BARKER LEMAR

Re: Response to February 12, 2018 DNR Comments (Emailed)
Request for Approval to Construct Cell FY18
Iowa City Landfill and Recycling Center
Permit No. 52-SDP-01-72P
Project No. IACLF 17007

IOWA CITY LANDFILL AND RECYCLING CENTER

2
5 **WEST SIDE SLOPE (TDA)**
NOT TO SCALE

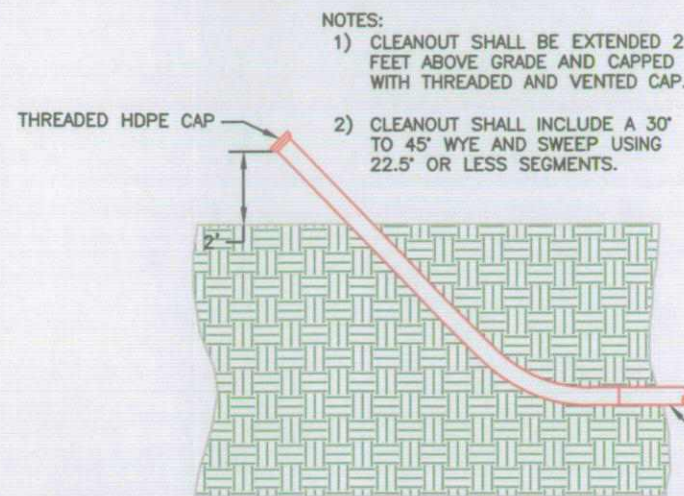
On the western sideslope of the cell, it is proposed to utilize tire-derived aggregate (TDA) as the leachate drainage media. We presume that the material used will be the standard 2-inch nominal material from Liberty Tire, but we request confirmation of this and revision to the Required Result column of Table 3.2, if appropriate.

Your TDA specification allows up to 5% of the total quantity used to have bead wire that protrudes 1/2-inch or more from the cut edge of the rubber. We are primarily concerned that the 10 oz geotextile that underlies it may not provide sufficient puncture protection to the geomembrane (GM). To address this concern, we offer the following options for your consideration-

- 1. Submit stress column test results of the TDA with the specified 10oz. geotextile and GM that demonstrates sufficient protection is achieved (inspection for damage to the geotextile or point deformations/punctures of GM).***
- 2. Revise the geotextile specification to utilize a 32 oz geotextile for this application. No stress column testing is required when this weight geotextile is used because of our experience with it. (It was used in 2017 at Dubuque Metro for their new cell.)***

We have considered the options set forth above and prefer Option 2, replacement of the current 10 oz/sy geotextile with the recommended 32 ounce (oz)/square yard (sy) geotextile. To implement this change, the following documents have been amended:

- Appendix 1.G Puncture protection. The narrative has been changed to specify a 32 oz/sy geotextile over the FML and beneath the FML. A revised page is in Attachment A; please replace pages 1 and 2 of Appendix 1.G.
- Appendix 2 Quality Control and Assurance Program. The QC&A Program was revised to specify a 32 oz/sy geotextile. Please replace pages 2-2, 2-3, 3-1, 3-2, 3-3, and 3-4 with the pages included in Attachment B.
- Appendix 5 – Plan Sheets. Specifications on the appropriate plan sheets have been revised to require 32 oz/sy geotextile beneath areas with TDA. Please replace plan sheets 5 and 6 with plan sheets in Attachment C.

- 1) 32 OZ GEOTEXTILE ONLY OVER TDA AREA

DESCRIPTION: REVISED DETAIL 2/5
